TSG-RAN Meeting #28
Quebec, Canada, 01-03 June 2005

RP-050326
agenda item 8.6

Title: CR on 25.309 (Stage 2) on FDD Enhanced Uplink

Title: ⌘ Introduction of resource management considerations and refinement of the scheduling mechanism

Figure 9.2.1-1: Timing relation for Relative Grant

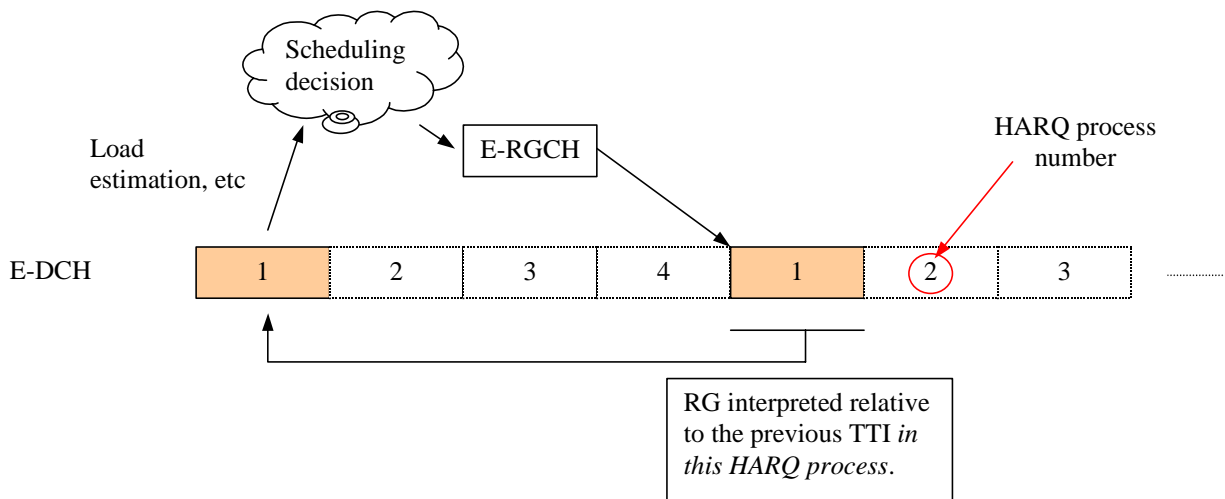
- If the activation flag is set to 'All' and the secondary E-RNTI is not configured:
 - All L3-enabled processes are deactivated (if a process was inactive it remains inactive, if a process was active it becomes inactive);
 - In case of 2ms TTI and a Secondary Absolute Grant was received:
 - In case the Secondary Absolute Grant affects the SG, the SG is set to the received value.
- If no "Absolute Grant" is received by the UE in a TTI and the last SG update was due to a Primary Absolute Grant, then the UE shall follow the "Relative Grant" of the Serving E-DCH RLS:
- A Serving Relative Grant is interpreted relative to the UE power ratio in the previous TTI for the same hybrid ARQ process as the transmission which the Relative Grant will affect (see figure 9.2.1-1);

- When the UE receives a “DOWN” from at least one Non-serving E-DCH RL, it is interpreted relative to the UE power ratio in the previous TTI for the same hybrid ARQ process as the transmission which the Relative Grant will affect (see figure 9.2.1-1)~~S~~:
